MODEL	REV	CHANGE LIST	Model	CT3/5 MB BOARD	
			Page	FROM	TO
CT3/5 MB 31CT3MB0015 31CT3MB0031	1A	PAGE 2 --- Enable CLK48M from cloc k generator for the PLL circuit of 7411, and disable the ocsillator circuit of PCI7411 PLL. PAGE 3 --- Remove H/W shutdown circuit that supported ADM1032. PAGE 4 --- Use X7R type to replace Y5V type for CPU Decoupling/Bypass capacitor. PAGE 10 --- Add a terminal resistor R706 for -CODE_RST# to improve signal quality. PAGE 11 --- 1. Add a 10K pull-up resistor on MCH_SYNC# for booting. 2. Change the power plane of PCIE_WAKE# from 3VSUS to 3V_S5 to solve system can't turn off issue. 3. Change the power plane of ICH_THRM# and SCI_# from 3VSUS to +3V to reduce leakage. PAGE 12 --- We can also use 5VSUS to instead of 5V_S5 to save cost of MOSFET(A06402). PAGE 15 --- Add a level-shift cicuit for EDID interface. PAGE 17 --- 1. Add a off-page and a EMI solution for CLK48M. 2. Remove the reserve resistors (R693~R695) of parallel interface for PCI1510. PAGE 18 --- Remove R696, connect controller and power switch directly . PAGE 19 --- Change R682&R683 value from 56 ohms to 0 ohm cause of BOM error at A-test. PAGE 22 --- 1. Change MC3 type from Y5V to X7R to improv

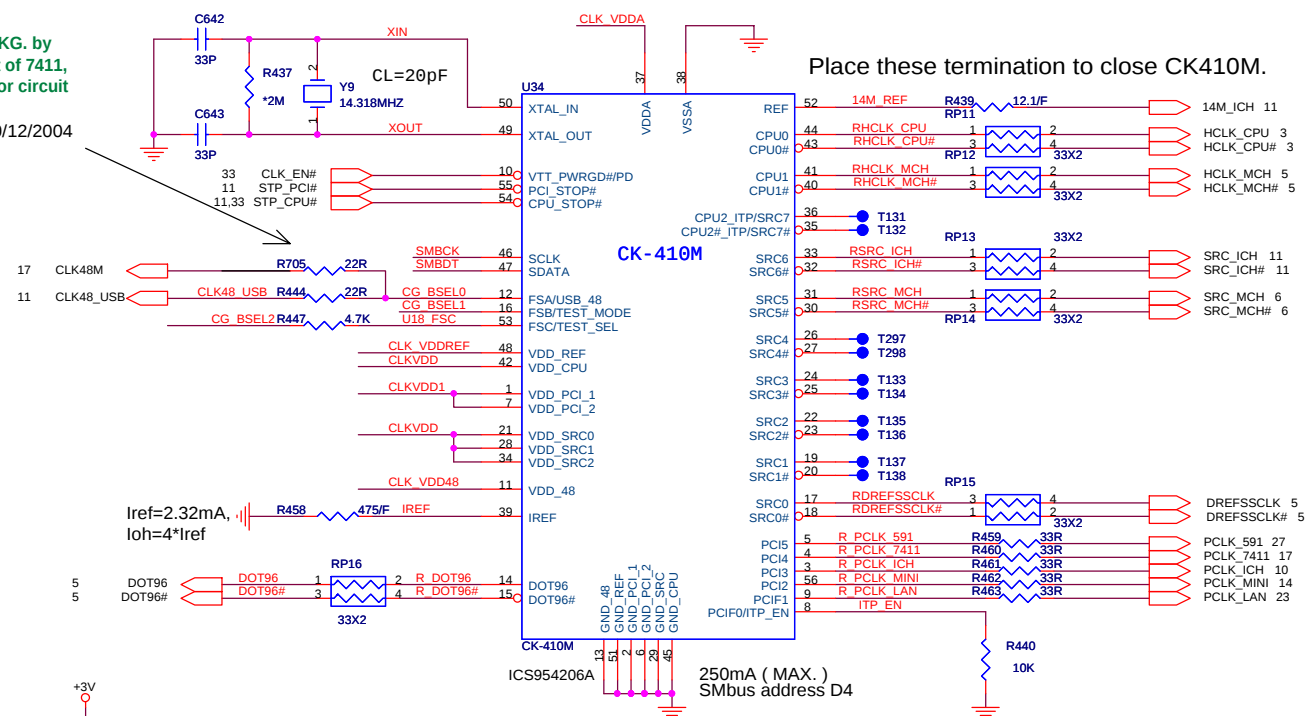
SI stage:
Enable CLK48M from CKG. by
R705 for the PLL circuit of 7411,
and disable the oscillator circuit
at PCI7411 side.

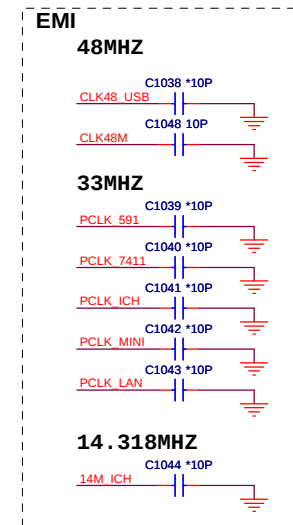
PV stage:
Add C1048 for CLK48M to get better EMI
performance.

Size	Document Number	Rev
Custom	CPU POWER / GND	2A
Date:	Monday, December 27, 2004	Sheet 4 of 39

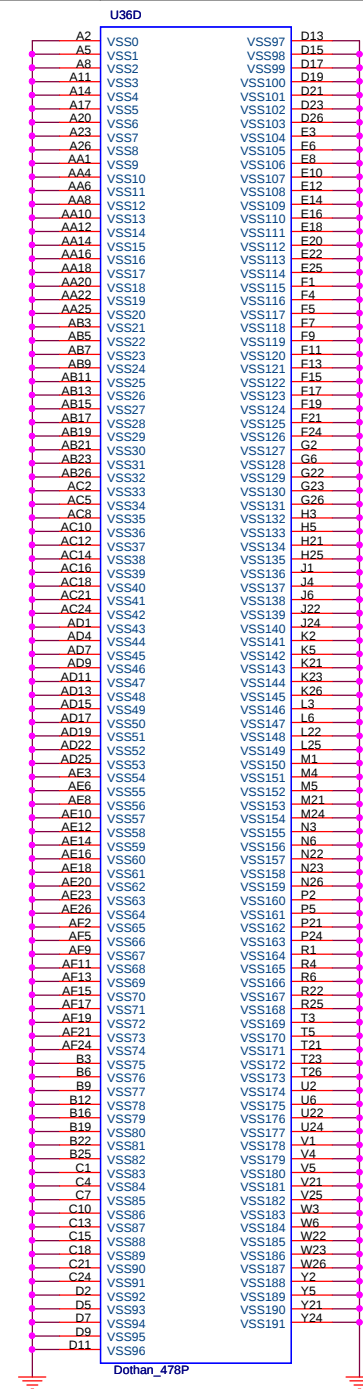
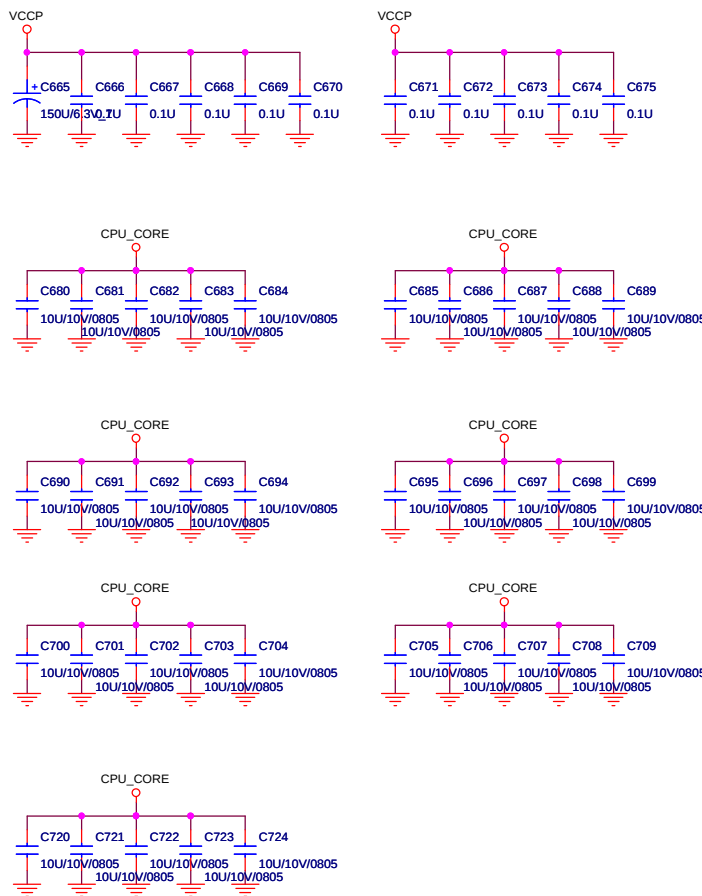
SI stage:
Use X7R type to replace Y5V type
for Decoupling/Bypass capacitor.

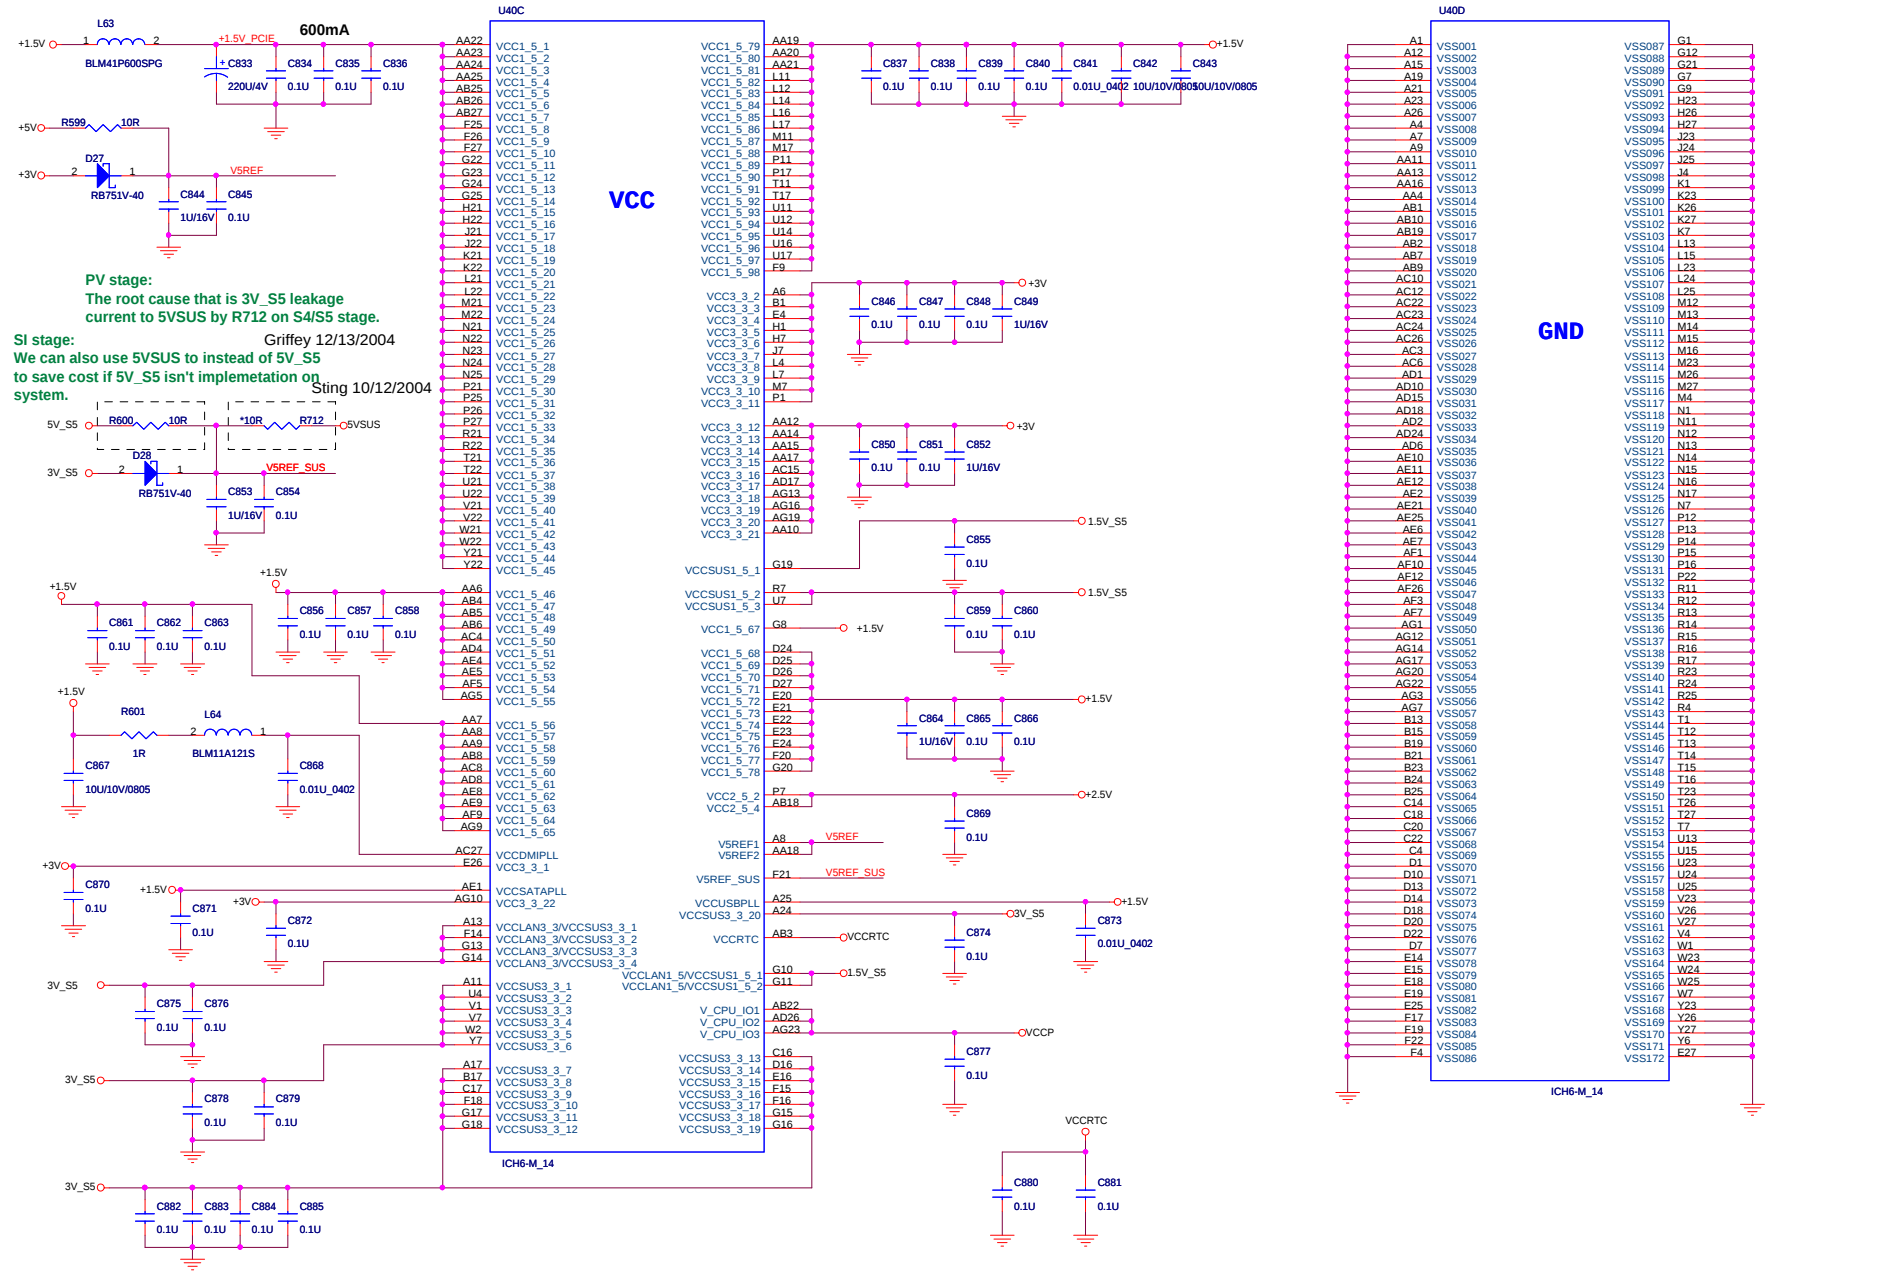
SI stage: Intel suggested us to add a terminal resistor R706 for -CODEC_RST to improve signal quality.

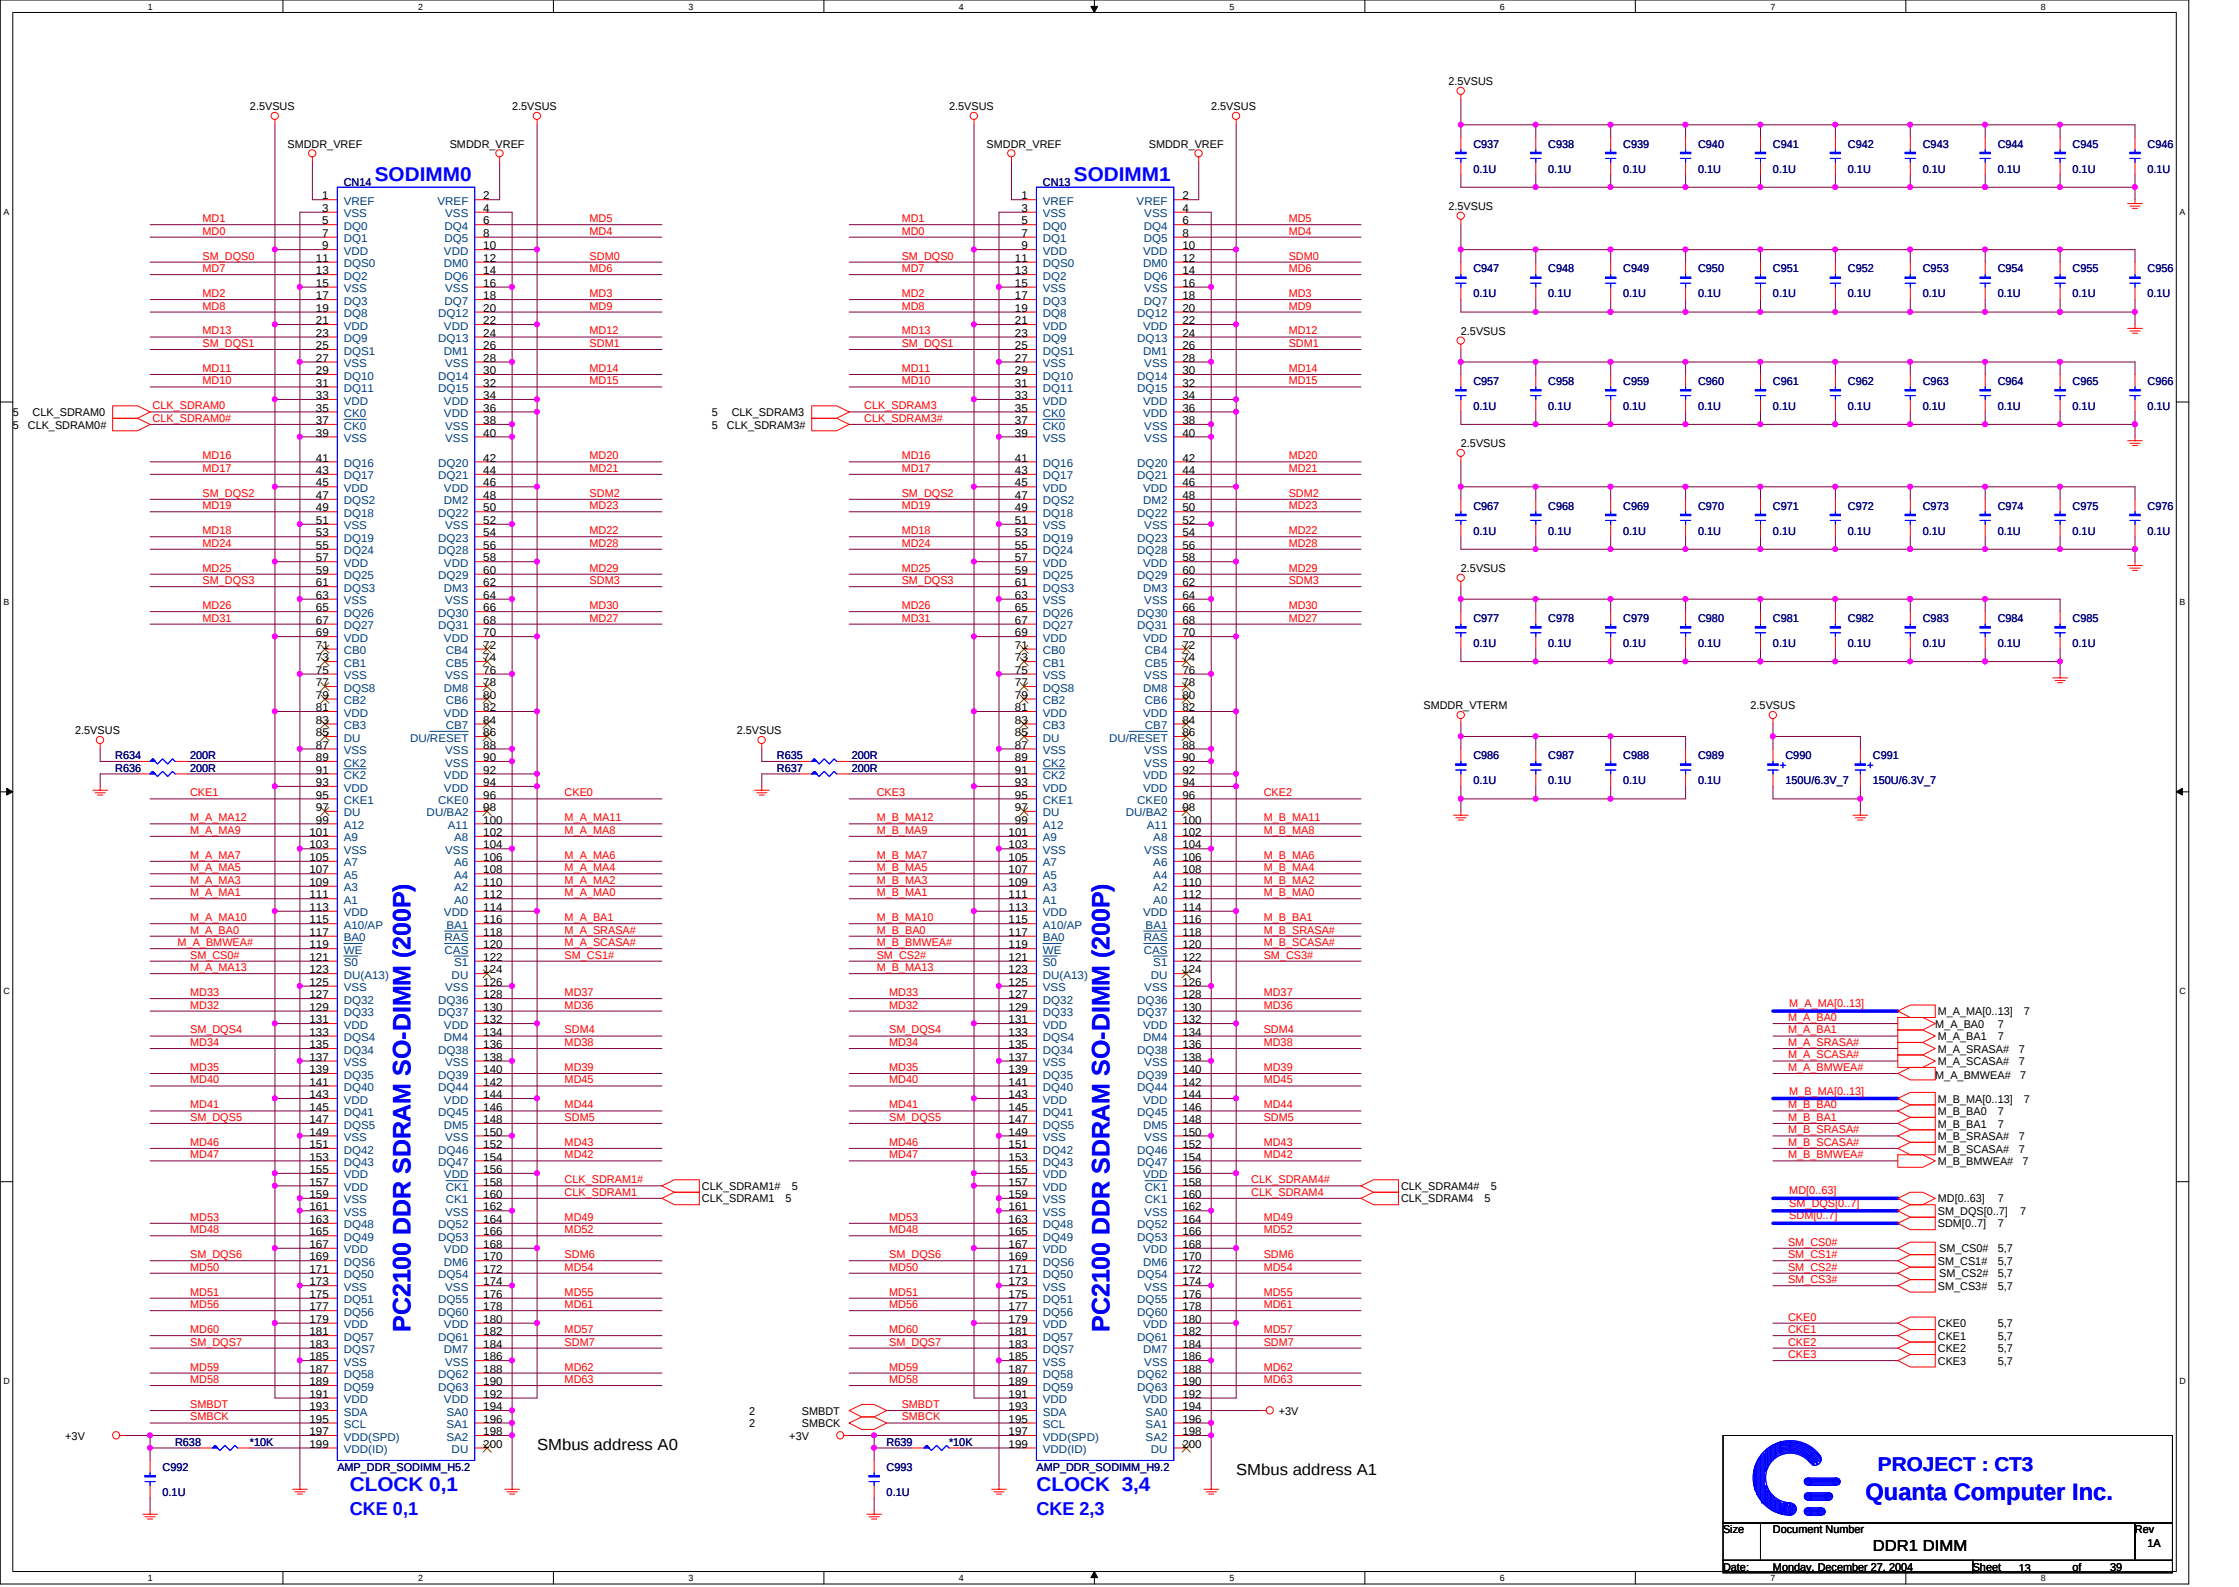
PV stage:
The root cause that is 3V_S5 leakage current to 5VSUS by R712 on S4/S5 stage.

SI stage:
We can also use 5VSUS to instead of 5V_S5 to save cost if 5V_S5 isn't implementation on system.

CARDBUS POWER SWITCH

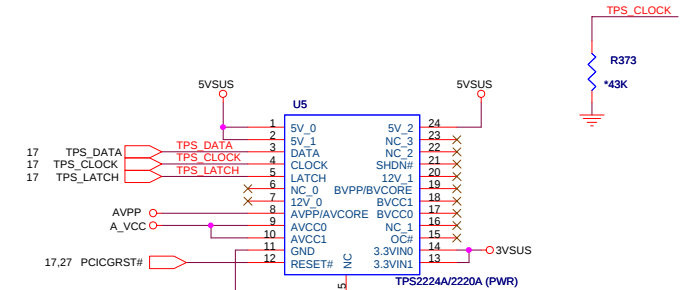
PV stage:
Remove unused PCI1510RVGF circuit.
